Rugby Football Union

Section 73 Application - Design Amendments Summary

Twickenham Stadium - East Stand Extension

28 April 2017

East Elevation - Approved (Drawing No. 15735 - 344 P01)

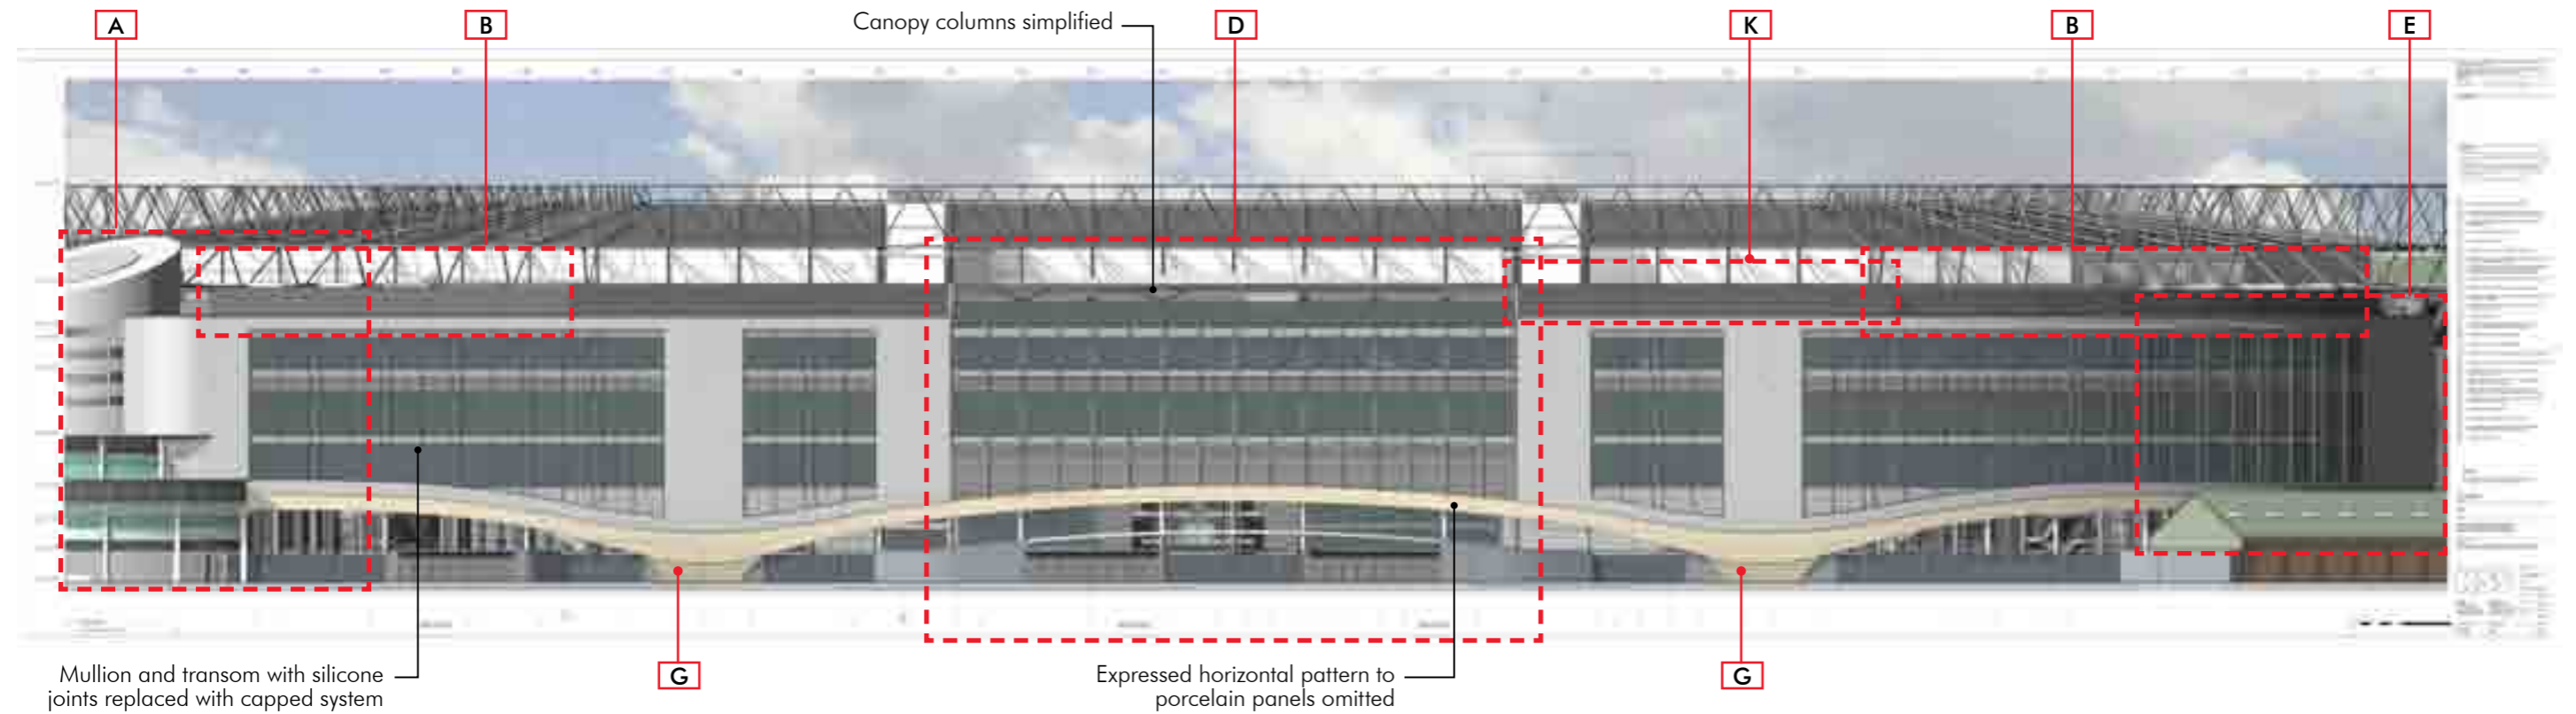
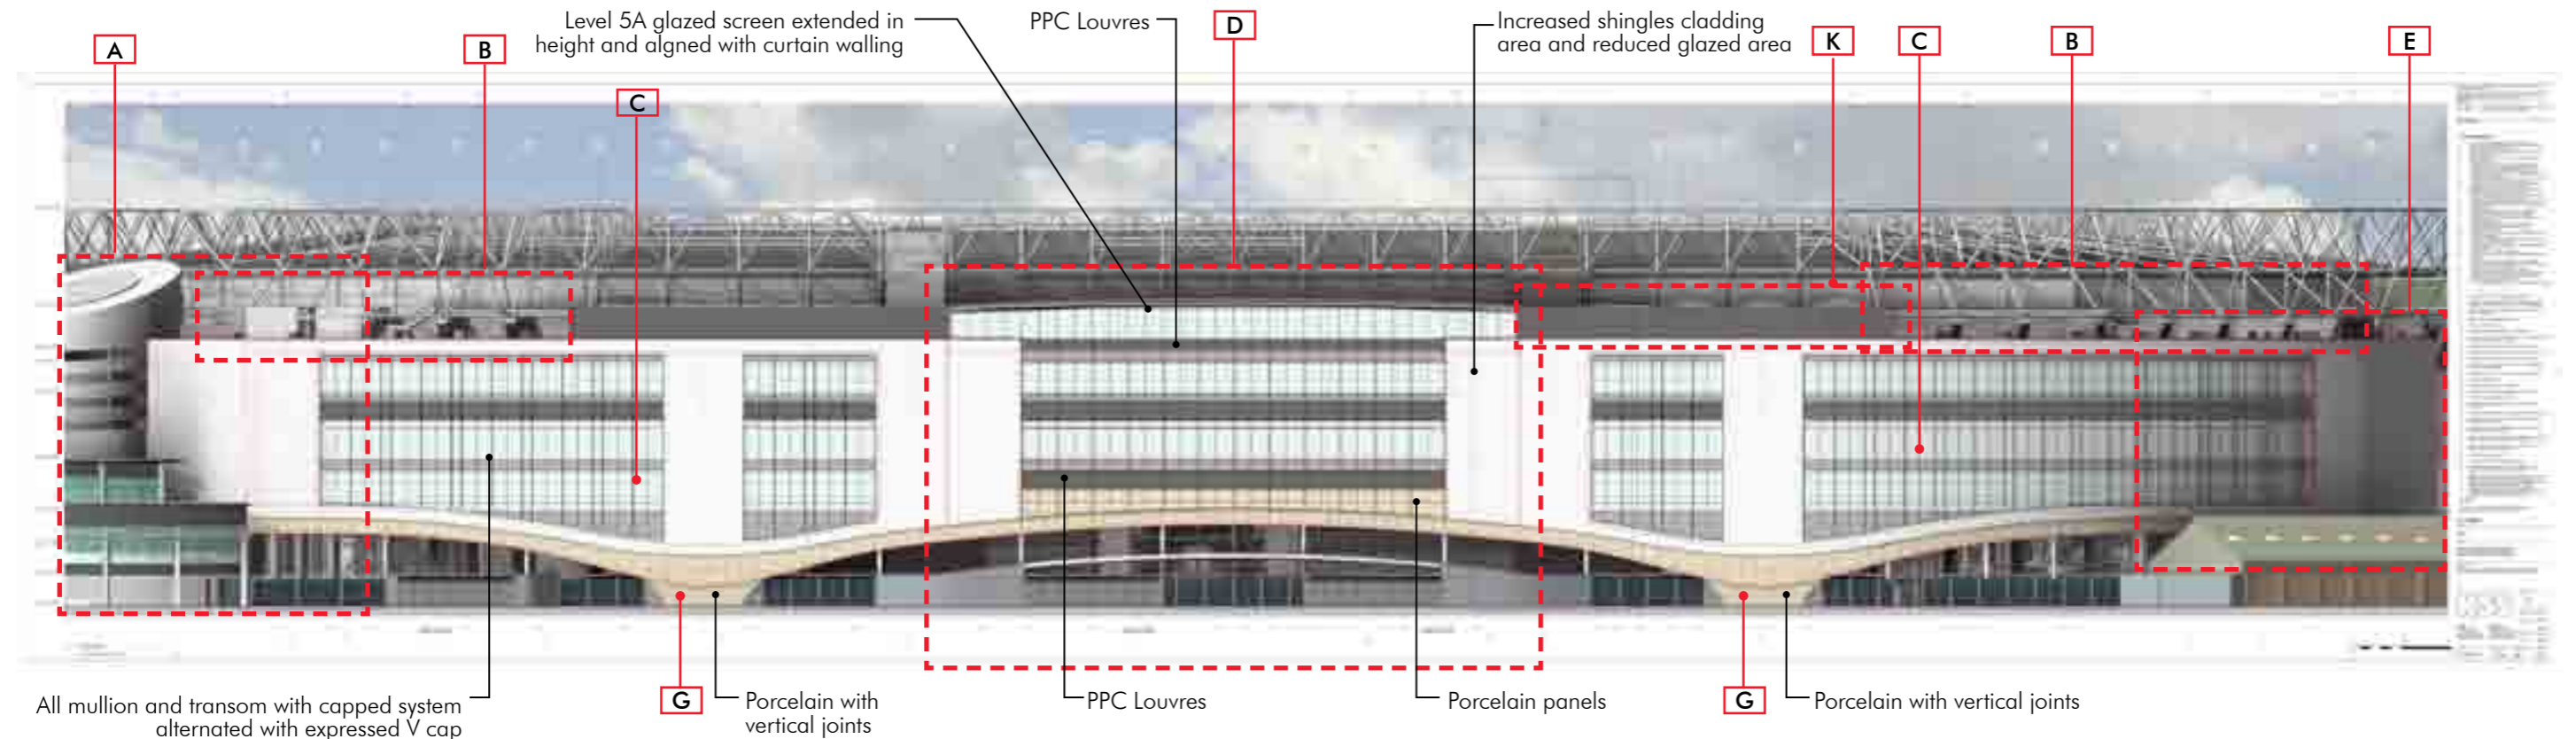
- The massing of the East stand extension that interfaces with the south stand extension has been reduced to improve the interface with the existing building and facilitate buildability.
- The shingles cladding area has been increased and extended towards the north. The curtain walling area has been reduced accordingly (refer to elevation drawings 342, 343 and 344 P01 & P02).

- The design of the canopy at Level 5A (external terrace level) and its supporting columns have been revised generally. The standing seam canopy finish has been replaced with a single ply membrane (refer to drawings 117, 202 P02 & P03 and 346 P01 & P02). The extent of the canopy cantilever has been reduced.

- The shingles cladding area has been increased and the curtain walling area has been reduced accordingly (refer to elevation drawings 344 P01 & P02 and 303 P02 & P03).

- The shingles cladding area has been increased and the curtain walling area has been reduced accordingly (refer to elevation drawings 341 P02 & P03 and 344 P01 & P02).
- The porcelain rainscreen cladding to the north lift has been replaced with polyester powder coated aluminium rainscreen cladding. The setting out of the panels has been revised accordingly.
- The area of green wall to the north end has been increased and the metal louvres have been removed.

- The porcelain pattern (between grid E9 & E10 and E24 & E25 at ground floor level) have been changed from horizontal to vertical (refer to visuals and drawing 344 P01 & P02).

Visual from North East Amended - Section 73

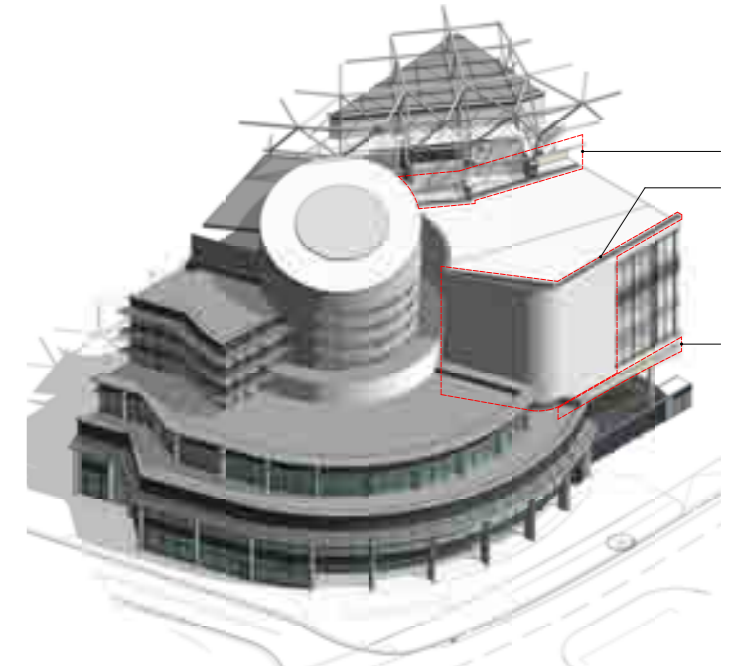
- The metal louvres located at Level 5A along the interface with the soldier columns of the existing East stand have been omitted. There is no impact on the design visually from the street (please refer to visualisations - 6000 series). An extract of the visuals have been included in this document for comparison.

Drawing No. 15735 - 343 P01 & 6000 P01

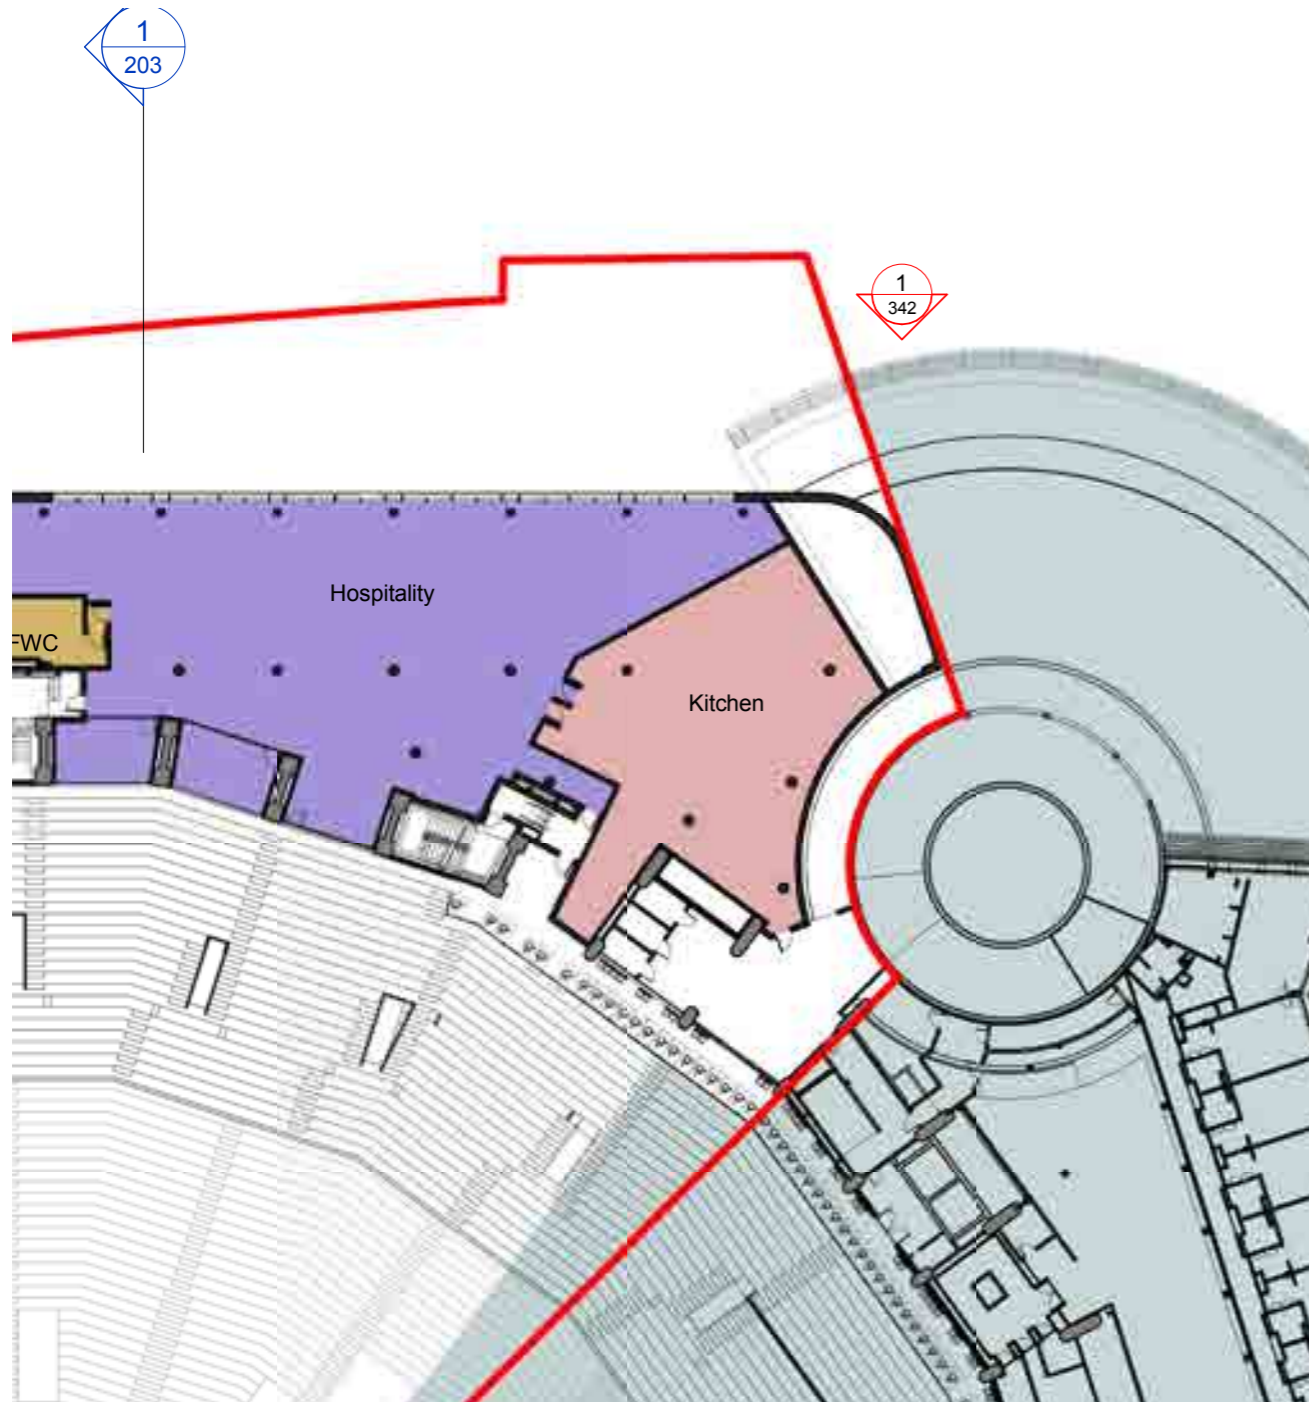
- The massing of the East stand extension that interfaces with the south stand extension has been reduced to improve the interface with the existing building and facilitate buildability.
- The shingles cladding area has been increased and extended towards the north. The curtain walling area has been reduced accordingly (refer to elevation drawings 342, 343 and 344 P01 & P02).
